PUBLIC HEARING MEMORANDUM

SUBJECT: **Petition #254-24** for SPECIAL PERMIT/SITE PLAN APPROVAL to allow a series of constructed retaining walls exceeding four feet at 6 Brush Hill Road

Re: Special Permit – 6 Brush Hill Road

As Built Plan
Special Permit Wall Plan
Prepared by: Verne T. Porter, Jr., PLS
Dated: March 28, 2024

Precast leaching chambers being installed

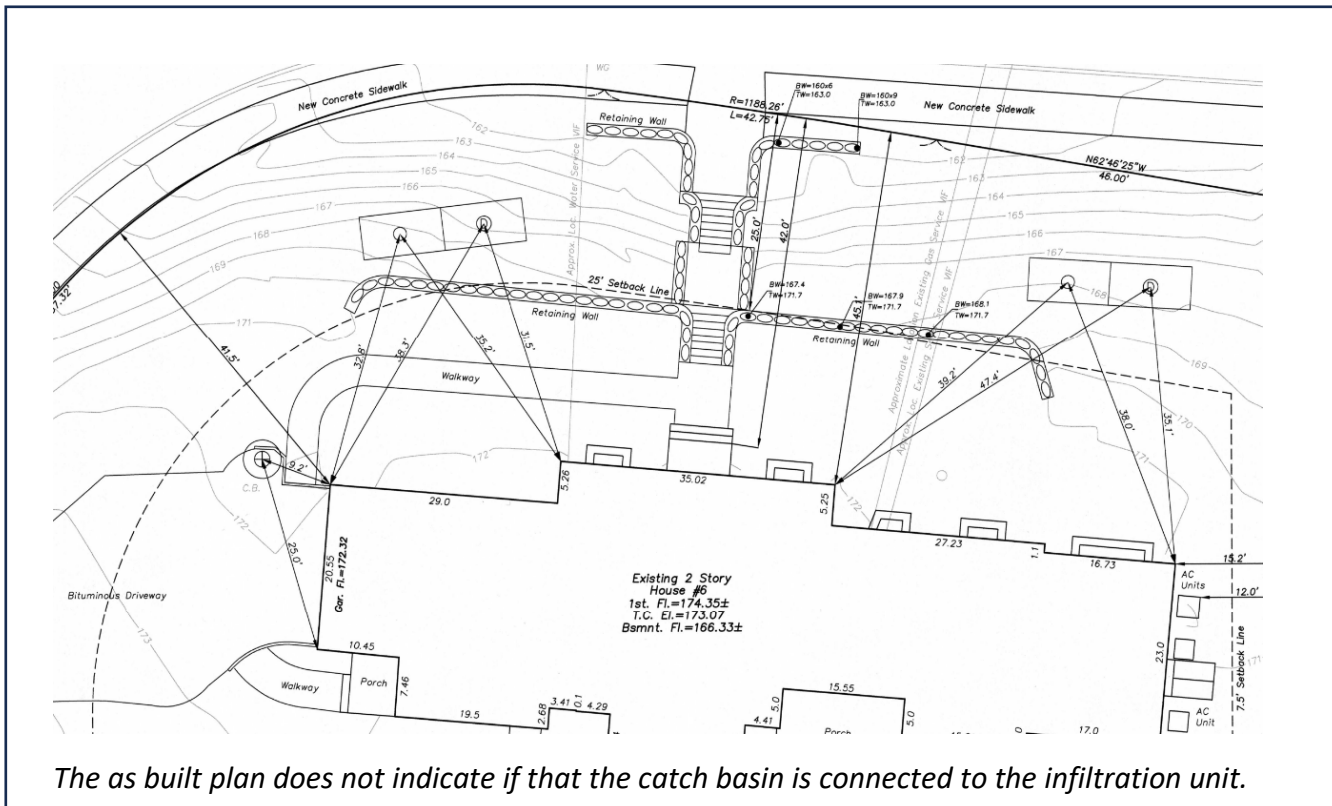
The special permit appears to be an after the fact filing. Based on a site visit the walls are completed and landscape crews were planting various plantings. The engineer of record has designed a stormwater collection system for the City's 100-year storm event which shows two infiltration systems in the front yard.

The plans did not have any details for the construction of the wall. The as built plan shows a catch basin in the corner of the driveway however it is unclear if it is connected to the leaching system.

The Operation and maintenance plan is not stamped by the engineer of record, this should be a stand-alone document and once approved it must be recorded at the registry of deeds and the book and page numbers shall be submitted to the DPW.
